## USB332x Family Silicon Errata and Data Sheet Clarification

This document describes known anomalies for all functional revisions of the USB332x device.

**FIGURE 1: RESISTOR DIVIDER CIRCUIT**

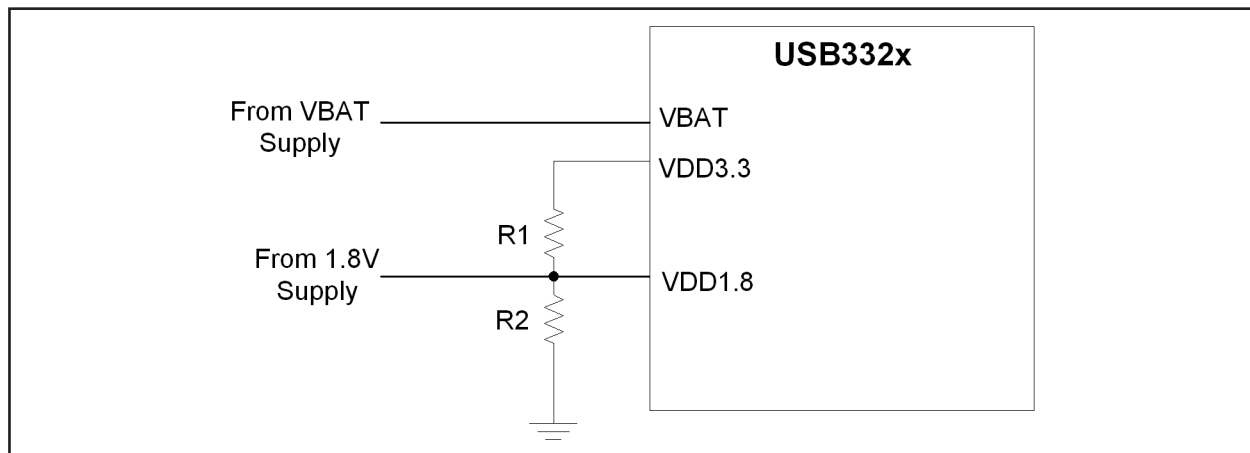
The VBAT (VDD3.3) pin may draw up to 1.3mA of current from the VBAT source when all of the following conditions apply:

1. The VDD1.8 supply is removed.
2. The VBAT supply is ON.

In this mode the VBAT (VDD3.3) pin should draw  $\leq 25 \mu\text{A}$ .

Removing supply voltage from both VBAT and VDD1.8 produces a leakage current of 0  $\mu$ A. If the customer elects to leave VBAT on while VDD1.8V is off, the USB332x may exhibit increased current draw (>25  $\mu$ A) from the VBAT (VDD3.3) supply when in Suspend Mode. USB functionality is not affected

- Leave the VDD1.8 supply ON whenever voltage is applied to VBAT. Standby current will be  $\leq 25 \mu$ A.
- Supply voltage on VBAT from a PMIC and switch it off whenever VDD1.8 is switched off. Standby current will be 0  $\mu$ A.
- Add a LDO regulator with enable between VBAT and the battery which can be switched off whenever VDD1.8 is switched off. Standby current will be 0  $\mu$ A.
- Add a resistor divider between VDD3.3 and VDD1.8 supplies, as shown in [Figure 1](#):

Where:

R1 = 210 k $\Omega$  1%

R2 = 309 k $\Omega$  1%

**Note:** If there are other devices attached to the 1.8V on the customer platform, those device impedances need to be taken into account.

Standby current will be  $\leq 30 \mu$ A.
